**Subject: Docket Nos. 50-361 and 50-362
Response to a Request for Additional Information regarding
Amendment Applications 270 and 255
Proposed Changes to Specific Regulatory Guide Commitments San
Onofre Nuclear Generating Station, Units 2 and 3**

SONGS SPENT FUEL POOL ISLAND LAR
DRAFT RAI RESPONSES

SONGS FUEL HANDLING BUILDING

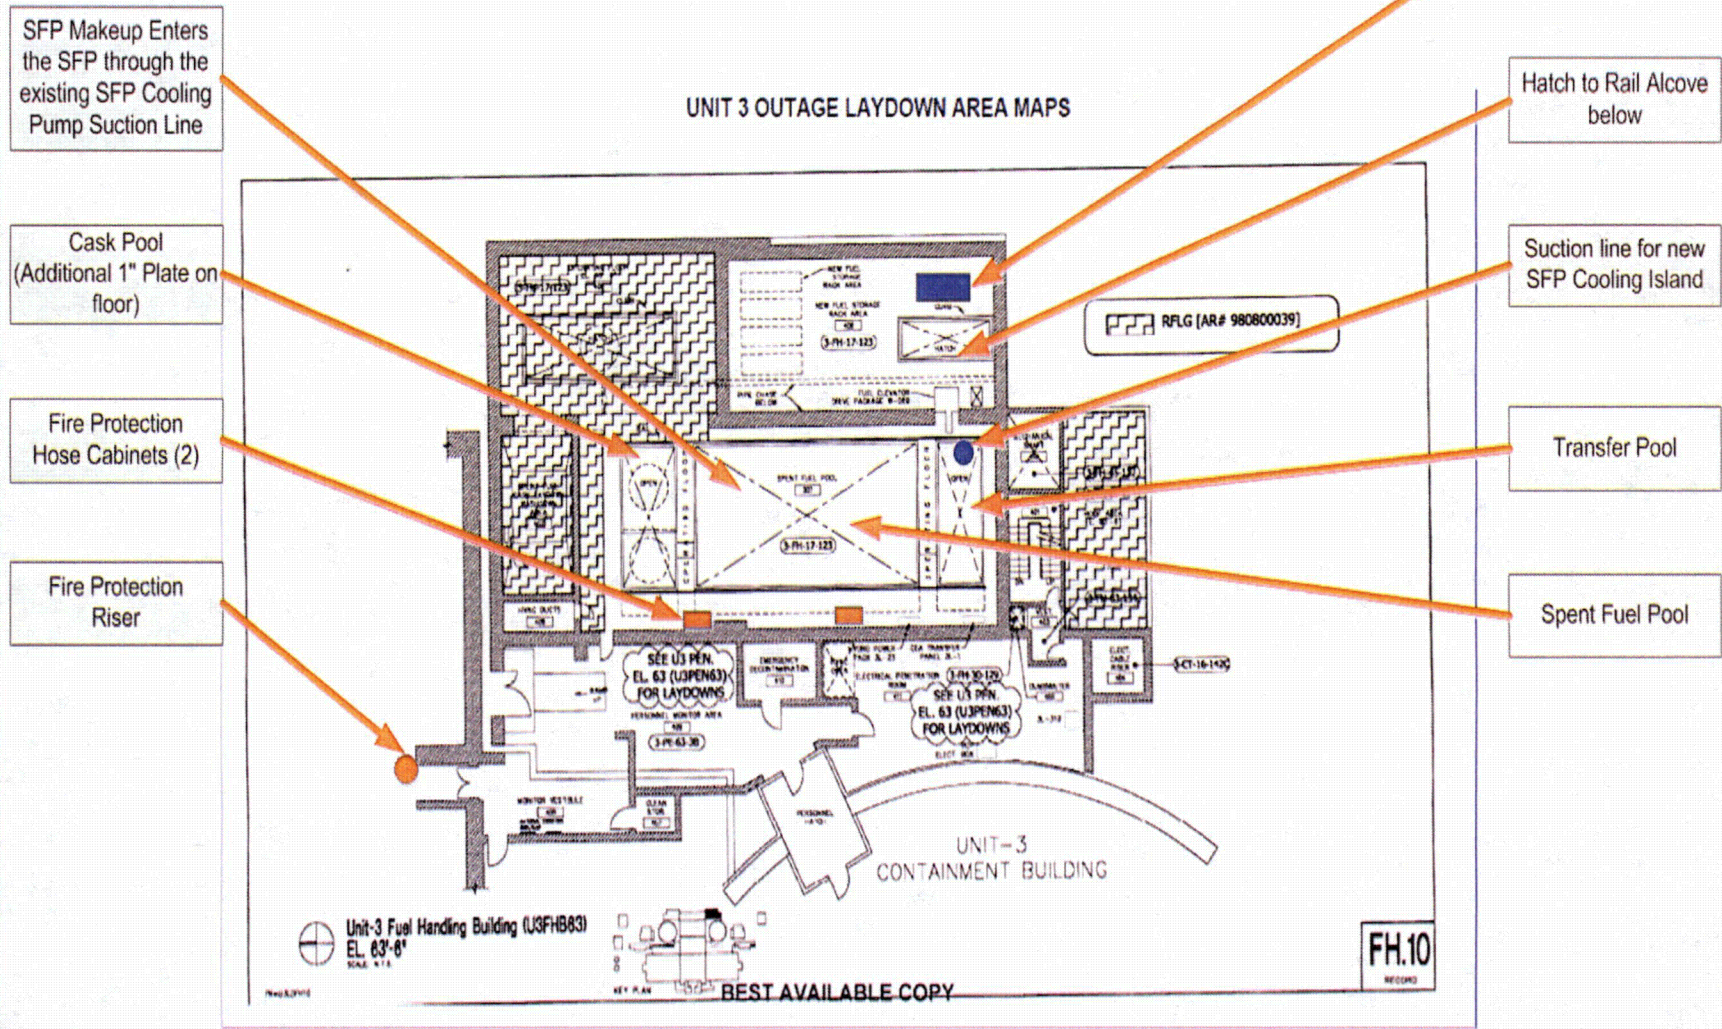
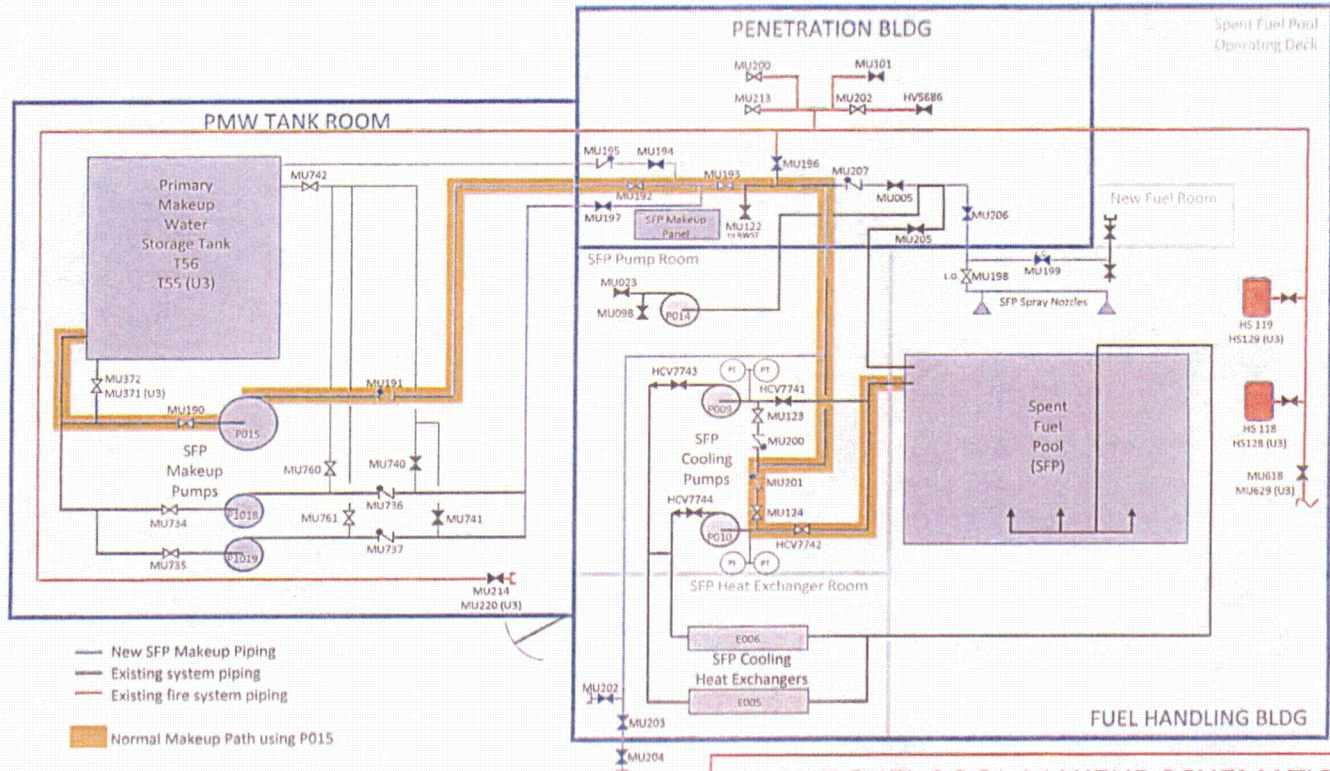
- B. Provide a diagram of the spent fuel handling building identifying: 1) the location of the pools; 2) the location of permanent makeup lines; 3) the location of standpipe connections that could be used for makeup; and, 4) the path(s) designated within the fuel handling building for SFP makeup water addition using hoses from the various alternate makeup sources.

Attachment 1 includes sketches depicting the requested information and related pictures of key equipment and staged resources for illustration.

The SFP Makeup Modification currently being installed also adds a connection from the Fire System to the Makeup injection line which eliminates the need to enter the pool operating floor to access the hose cabinets. It also provides an additional nozzle outside the Fuel handling Building on the east road that will enable outside sources of water to enter the makeup injection line without staging any internal hoses or accessing the pool operating floor.
